## Public Service Commission

**DATE:** April 1, 2014  
**TO:** Carlotta S. Stauffer, Commission Clerk, Office of Commission Clerk  
**FROM:** Kelley F. Corbari, Staff Attorney, Office of the General Counsel: *KFC*  
RAS Section  
**RE:** Documents to File in Docket No. 130290-EI  
Initiation of formal proceedings of Complaint No. 1115382E of  
Brian J. Ricca against Florida Power & Light, for failing to provide  
reasonable service

**From:** Robert Graves  
**Sent:** Monday, March 31, 2014 3:40 PM  
**To:** Kelley Corbari  
**Subject:** FW: FPL CIAC charges for North Port property  
**Attachments:** map.jpg

**From:** Brian J. Ricca [<mailto:brianricca@yahoo.com>]  
**Sent:** Monday, August 05, 2013 11:06 AM  
**To:** Elisabeth Draper  
**Cc:** Jim Dean; Patti Daniel; Paul Vickery; Ellen Plendl; Patti Daniel; Shonna McCray  
**Subject:** Re: FPL CIAC charges for North Port property

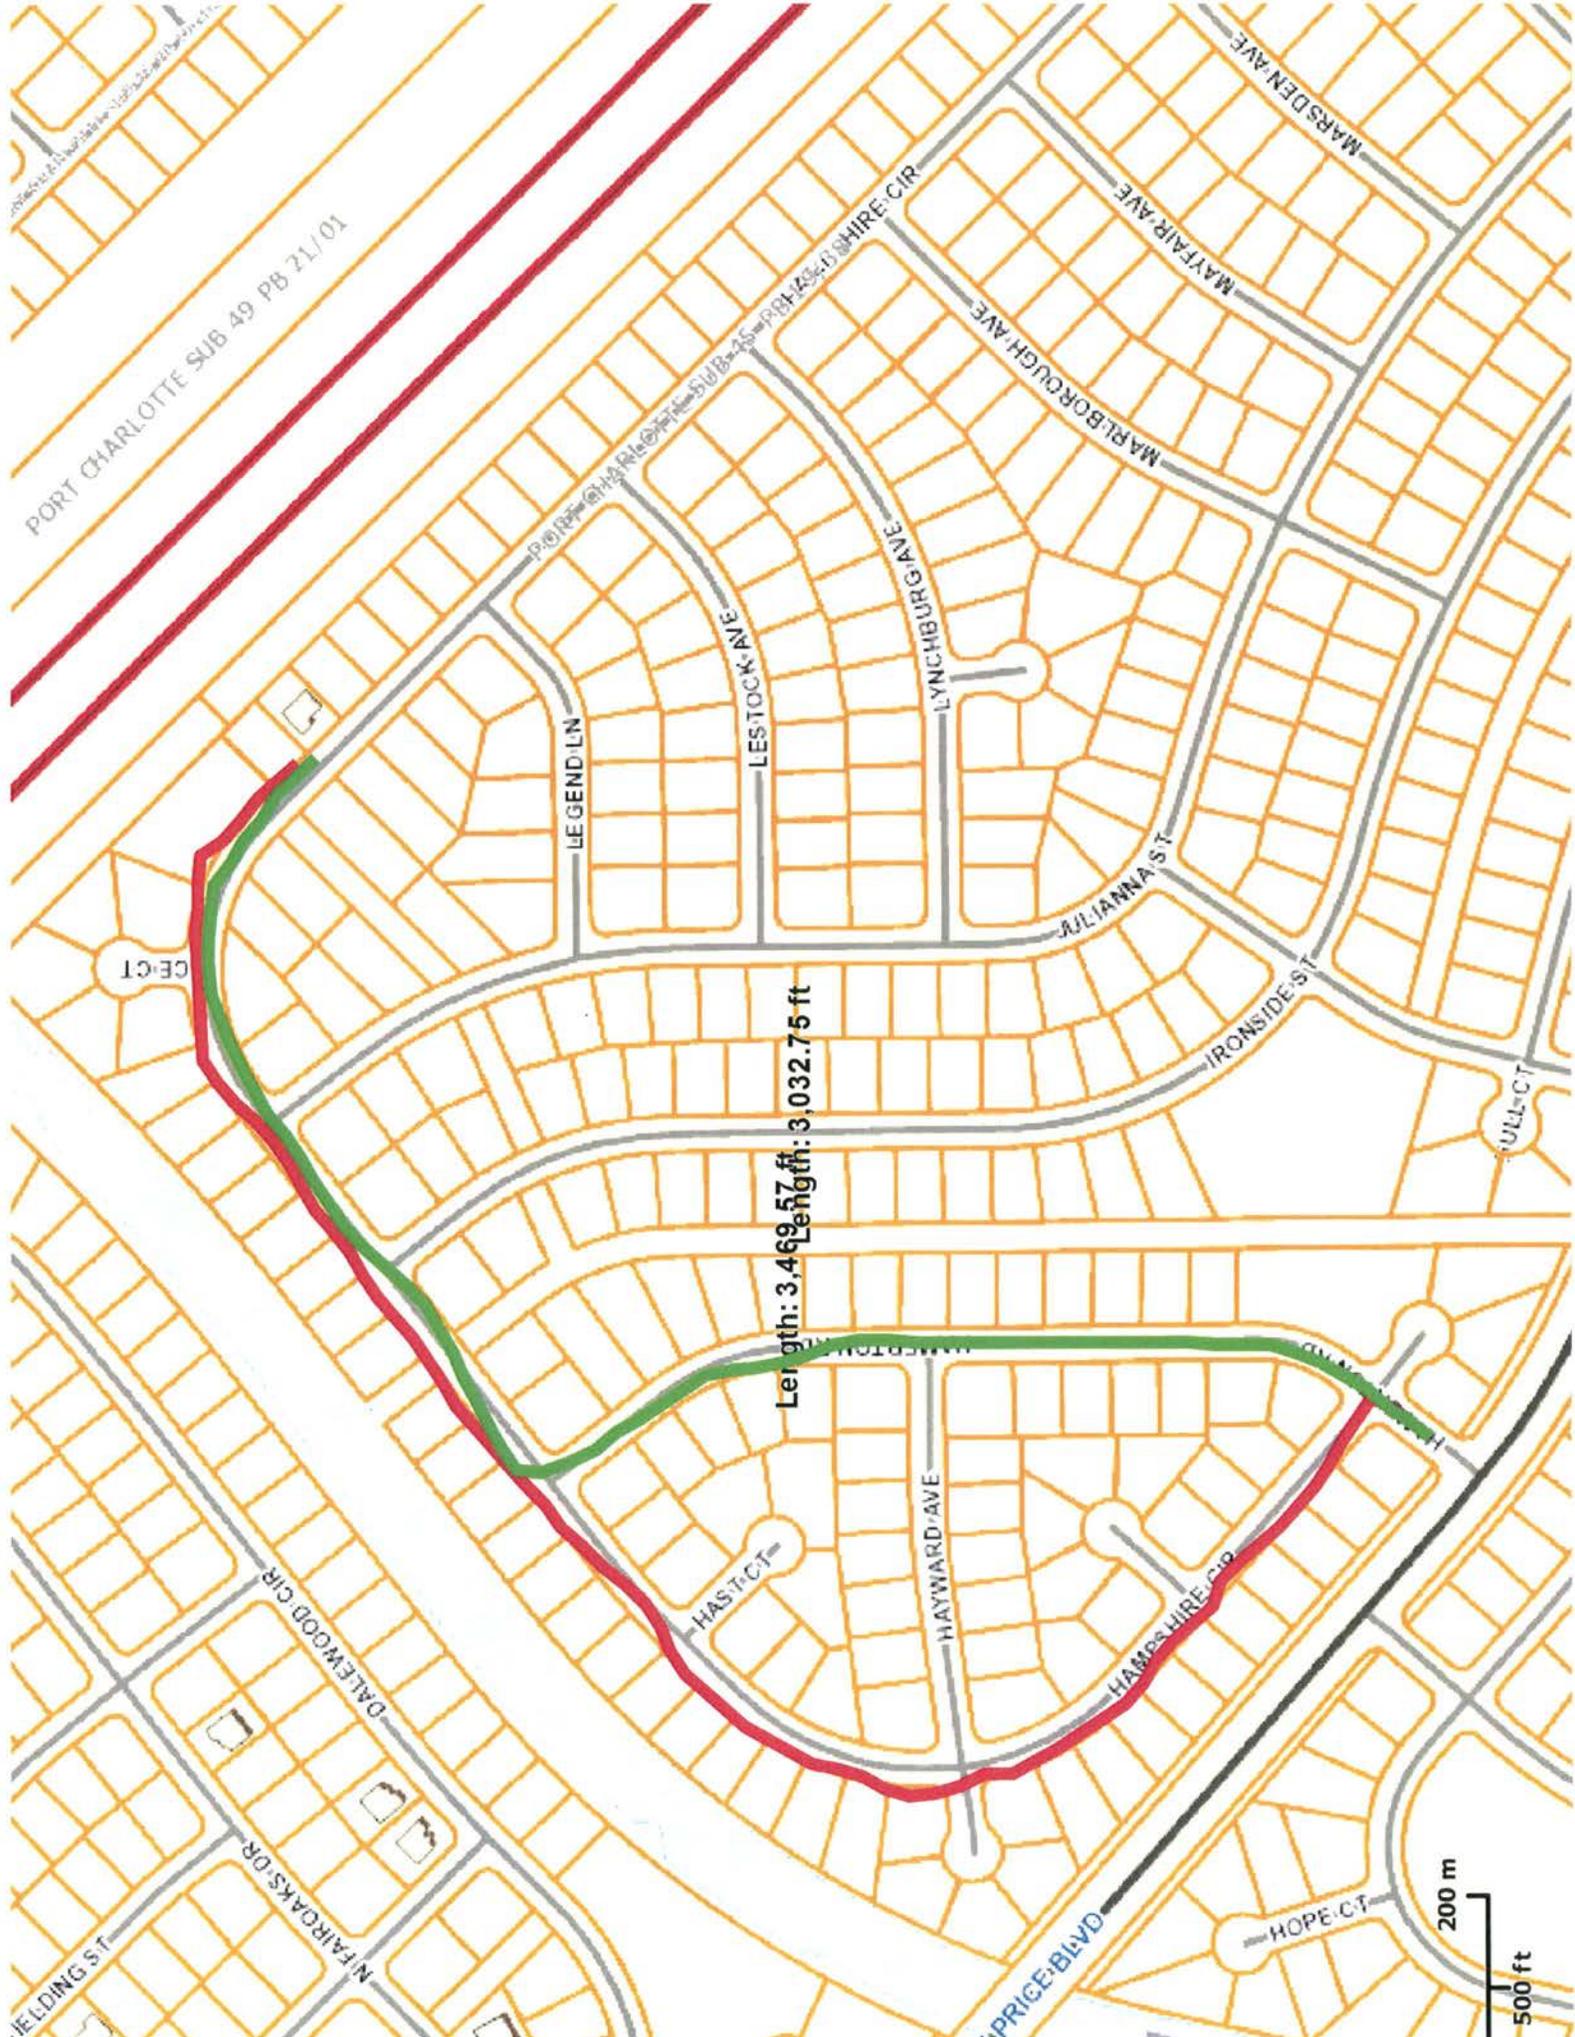
I have attached a map of the routes and the linear footage on quote does not seem accurate. The quote shows approx 4100+ ln ft required. The red line on map is the quoted route and approx 3500 ln. ft. and the green line is a shorter route at less than 3100 sq. ft. I would definitely want to go with the shorter route. These measurements are approximate but the green line would mean at least a 25% savings for me. I would also like to receive any additional credit as well for future buildings. I realize that mistakes happen but the end result is the most important thing for me. Time is of the essence for me however. Any reduction in costs is a huge plus for my planned budget.

As stated in Ms. Daniel's email to you, FPL's proposed contribution in aid of construction (CIAC) costs to serve your property at 7556 Hampshire Circle, North Port, Florida is consistent with Rule 25-6.064, Florida Administrative Code, which provides the guidelines for determining the cost for new or upgraded facilities.

Our engineering staff reviewed the cost estimate and concluded that it is reasonable. Our staff also reviewed a google map of your property and surrounding areas. FPL seems to be correct in their response that the closest power is across the canal, but FPL cannot cross the canal because the permit was denied. It appears the next closest power is off of Price Blvd which is at the beginning of your subdivision. Your house is in the back of the subdivision. You also mentioned a project on I-75, however, the project is World Fiber's project and not an FPL project.
